Access Compliance Report

Public Rights-of-Way

Intersection ID: N/A	Main Street: TROJAN_DR	Cross Street: OUTLETS_BV	Location: S
ADA ID: 1FD8363BCD95	Ramp Type: PerpDiag	Initial Pass/Fail: Fail	Overall Compliance: No
		Severity Score: 8.75

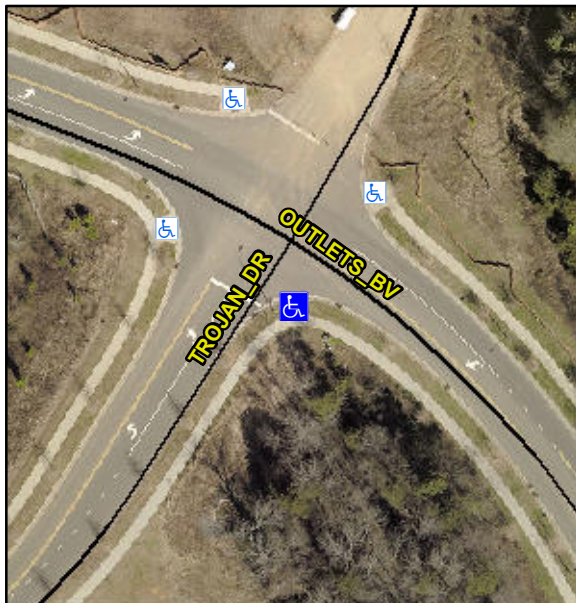
Not Found, R304.5.1

Compliance	Description	Data	Compliance	Description	Data
N/A	Ramp Length (in)	95.0	Yes	Ramp Slope (%)	6.8
No	Ramp Width (in)	47.0	Yes	Ramp XSlope (%)	1.2
N/A	Flare Type LT	N/A	N/A	Flare Type RT	N/A
N/A	Flare Slope LT (%)	N/A	N/A	Flare Slope RT (%)	N/A
N/A	Flare Traversable LT?	N/A	N/A	Flare Traversable RT?	N/A
N/A	Landing Length (in)	N/A	N/A	DWS Provided?	N/A
N/A	Landing Width (in)	N/A	N/A	DWS Contrast?	N/A
N/A	Landing Slope (%)	N/A	N/A	DWS Length (in)	N/A
N/A	Landing X Slope (%)	N/A	N/A	DWS Full Width?	N/A
N/A	Landing Curb? (Y/N)	N/A	N/A	DWS Offset (in)	N/A
N/A	Shared Landing?	N/A			
N/A	Gutter Ponding?	N/A	N/A	Gutter Slope (%)	N/A
N/A	Gutter Lip Ht (in)	N/A	N/A	Gutter X Slope (%)	N/A
N/A	Painted X Walk1?	No	N/A	Painted X Walk2?	No
	X Walk 1 Direction	To NE		X Walk 2 Direction	To NW
N/A	X Walk 1 Width (in)	N/A	N/A	X Walk 2 Width (in)	N/A
	X Walk 1 Slope (%)	1.4		X Walk 2 Slope (%)	1.6
	X Walk 1 X Slope (%)	1.5		X Walk 2 X Slope (%)	0.4

Remove & Replace Curb Ramp With Two New Directional Ramps or Equivalent.
